产品问题反馈 Product Feedback

»» 项目编号-Project NO. : UN20177

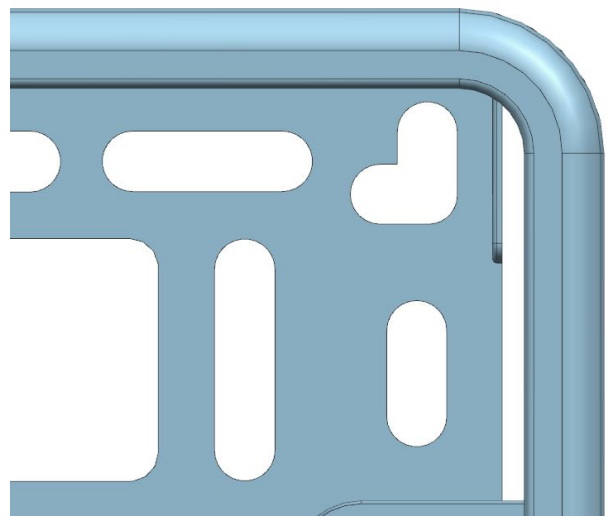
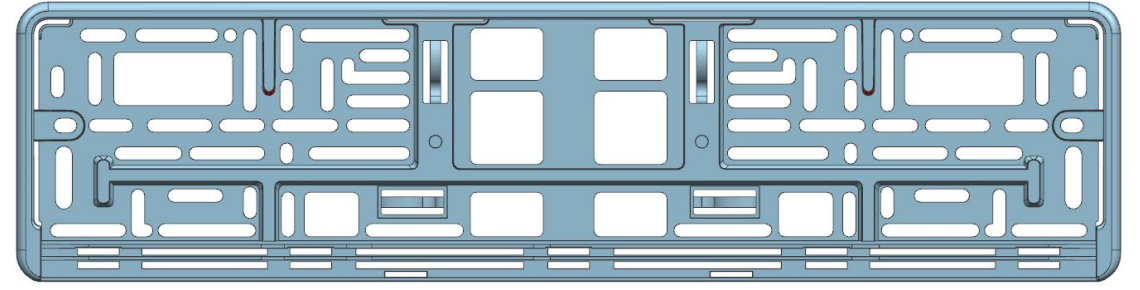
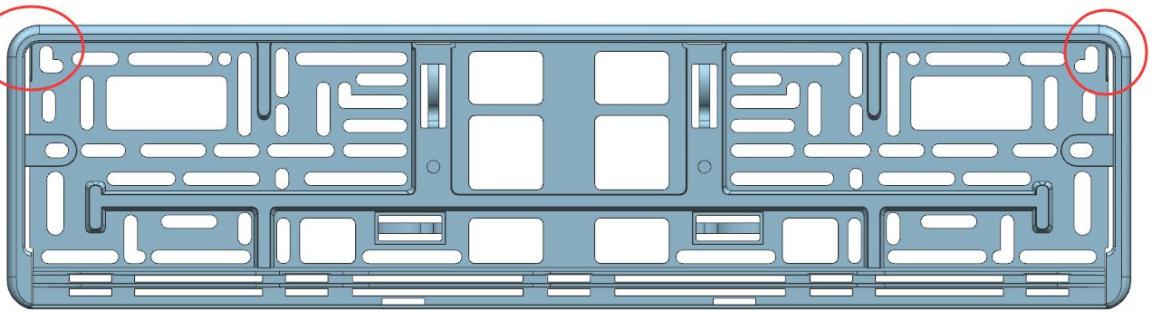
如图, 孔每边加大15mm
Can we make Hole length longer by 15mm on both sides ?

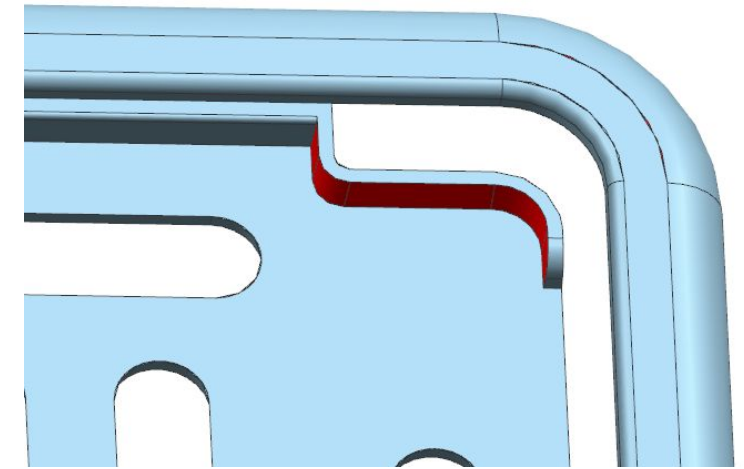
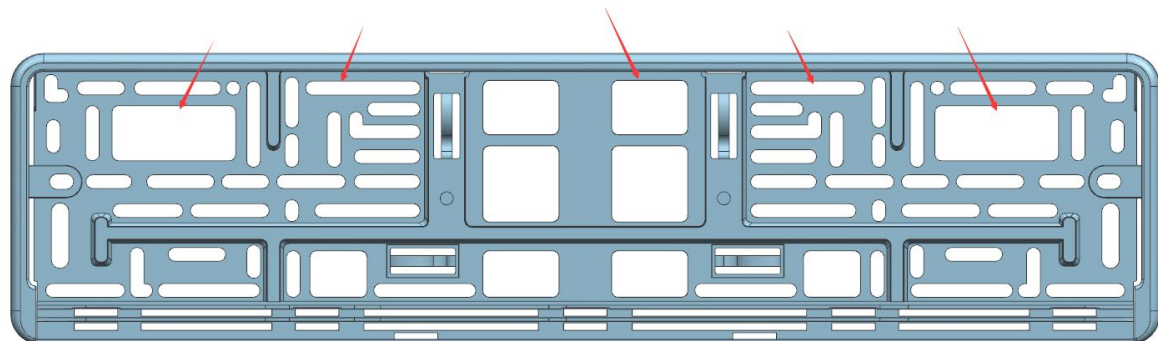
如图, 筋位改变
Can we make change on rib design

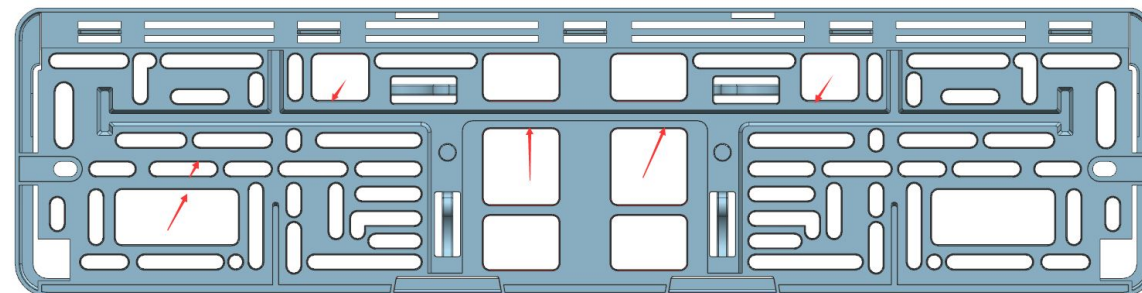
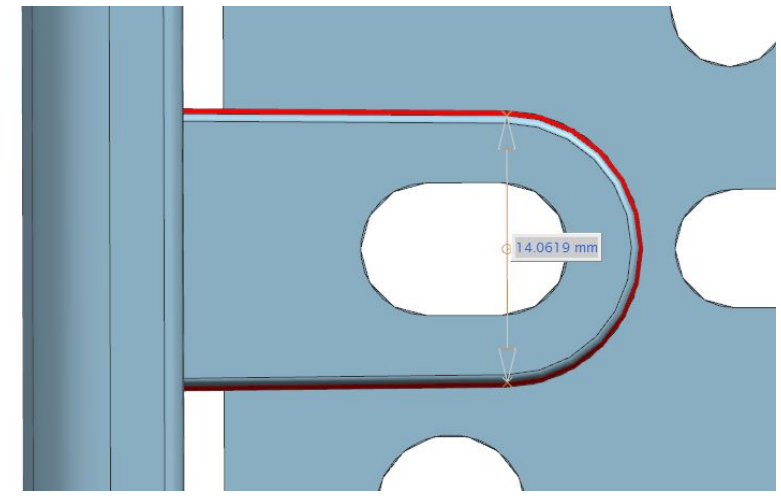
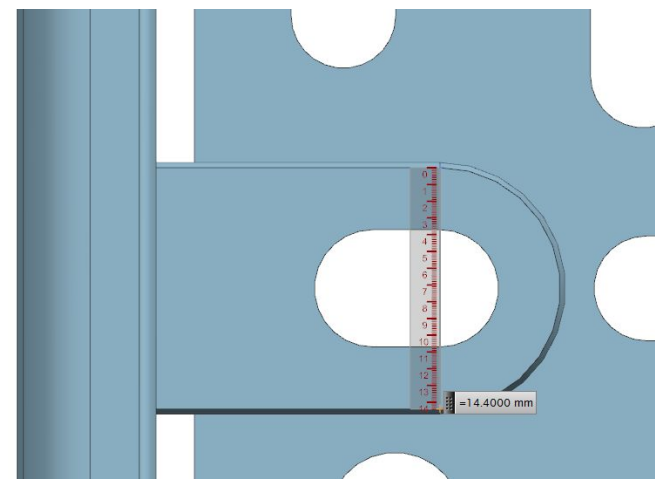
如图, 类似的孔, 斜度加大到10度
Can we make hole angle to 10 degree

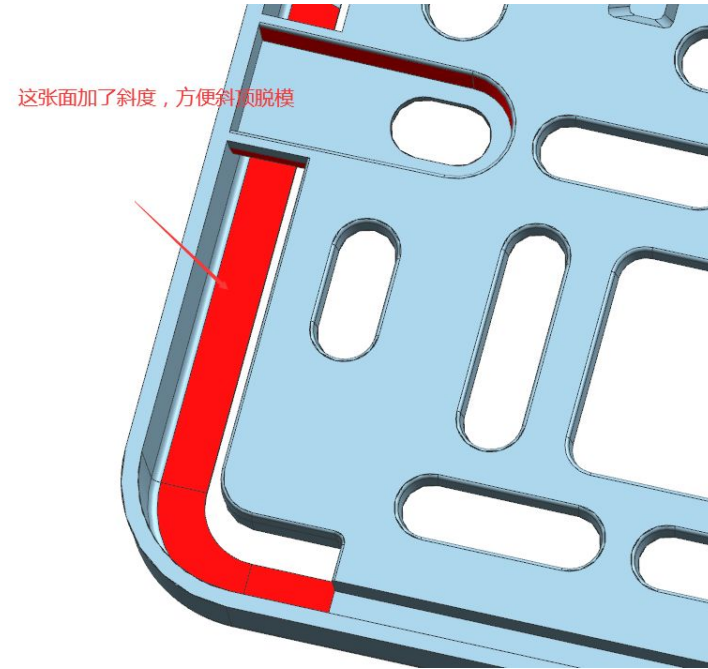
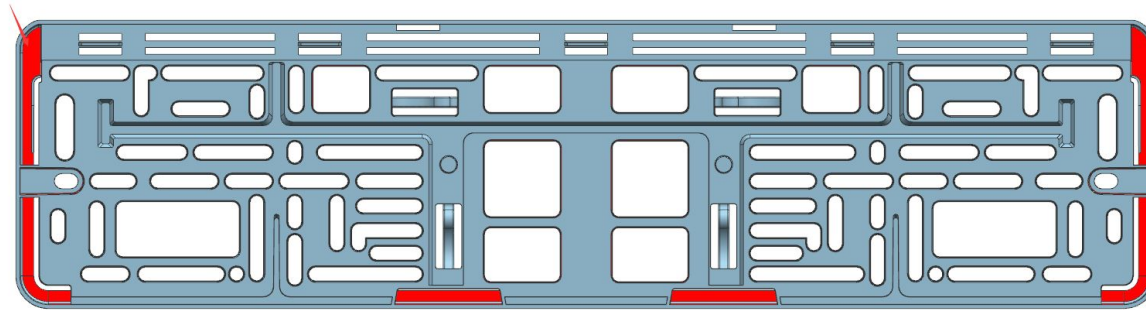
如图4个形状头部缩小单边0.2mm方便脱模
Can we reduce by 0.2mm on every side, it will be easier for mold ejection
